# UNITED STATES PATENT AND TRADEMARK OFFICE

10/509,757

<b>Office Action Summary</b>	<b>Application No.</b> 10/509,757	<b>Applicant(s)</b> TERADA, YUICHI	
	<b>Examiner</b> JOSEPH CORRIGAN	<b>Art Unit</b> 3744

## **DETAILED ACTION**

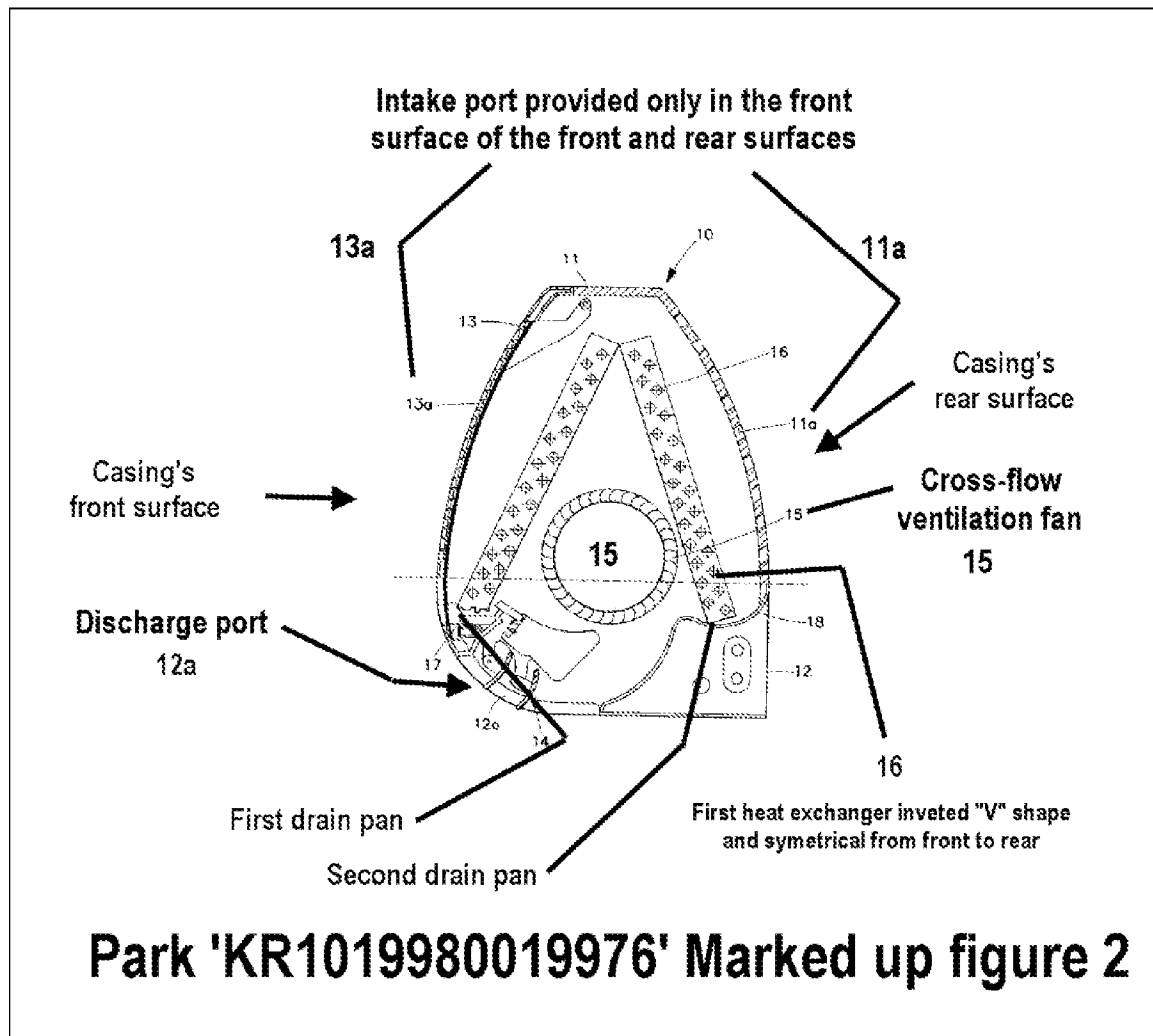
In re claims 1 and 3, King discloses an indoor unit of an air conditioner comprising: a casing having a front surface, a rear surface, a discharge port 12a and an intake port 11a, 13a provided only in the front surface of the front and rear surfaces; a ventilation fan 15 disposed in the casing to rotate about a

rotation axis, the ventilation fan being a cross flow fan that is arranged to blow air in a direction perpendicular to the rotation axis out of the discharge port of the casing; and a heat exchanger 16 disposed in the casing of the indoor unit so as to cover the ventilation fan, the heat exchanger 16 including a first heat exchange unit 16 having an approximate inverted V shape in cross-section, symmetrical from front to back (see marked up figure 2 of Park); however, Park fails to explicitly recite a second heat exchange unit that is connected at an angle with one end of the first heat exchange unit, and a third heat exchange unit that is connected at an angle with another end of the first heat exchange unit, the second heat exchange unit and the third heat exchange unit respectively extend downward from respective front and rear lower ends of the first heat exchange unit and the second heat exchange unit and the third heat exchange unit have approximately the same length.

**Yamashita et al 'JP-06094256' Marked up figure 8**

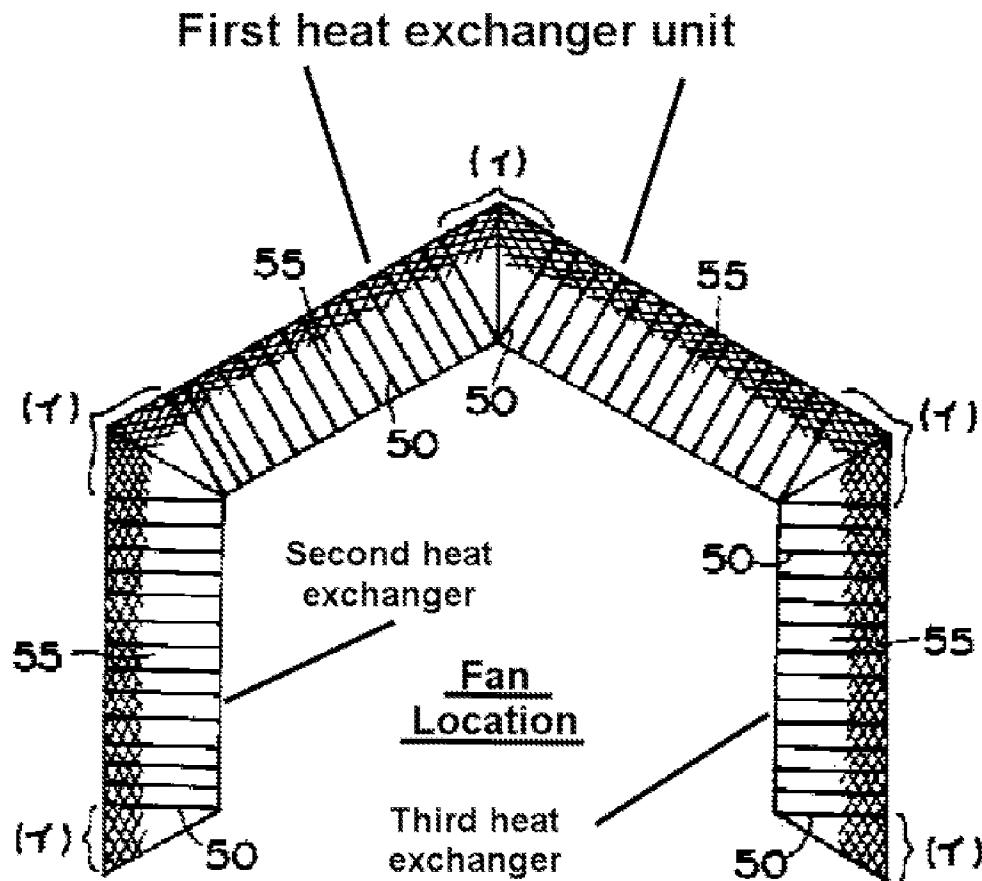
Yamashita et al teach a second heat exchange unit that is connected at an angle with one end of the first heat exchange unit, and a third heat exchange unit that is connected at an angle with another end of the first heat exchange unit, the second heat exchange unit and the third heat exchange unit respectively extend downward from respective front and rear lower ends of the first heat exchange unit and the second heat exchange unit and the third heat exchange unit have approximately the same length and symmetrical from front to back (see marked up figure 8 of Yamashita et al.)

Therefore, it would have been obvious to one of ordinary skill in the art at the time of the invention was made to modify King with four-section inverted V-shaped heat exchanger symmetrical from front to rear in a surrounding fashion as taught by Yamashita et al in order to advantageously draw air at right angles through the heat exchanger allowing for less resistance through its fins, and thereby, conserving energy.
